# IEEE 802.1Qdq/D0.2 Comment #4

Max Turner, Ethernovia

2022-11-16

**Figure X-5—The worst-case timing of the last frame**

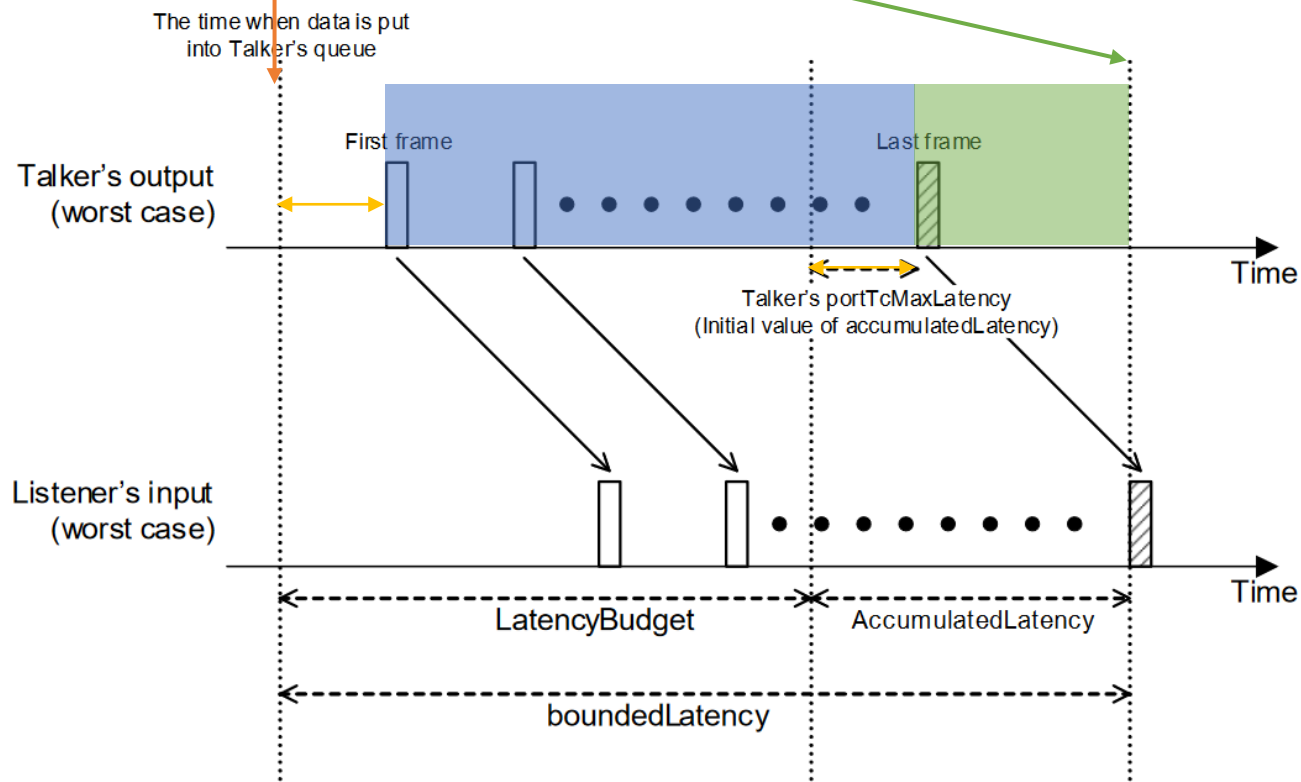
$$t'_i = t_i + \text{Latency}(i) = t_i + \frac{\sum_{k=1}^{n_i-1} \text{FrameLength}(i, k)}{\text{ShapingRate}} + \text{FrameLatency}(i, n_i) \quad (\text{X-2})$$

$$t'_i = t_i + \text{Latency}(i) = t_i + \frac{\sum_{k=1}^{n_i-1} \text{FrameLentgh}(i, k)}{\text{ShapingRate}} + \text{FrameLatency}(i, n_i) \quad (\text{X-2})$$
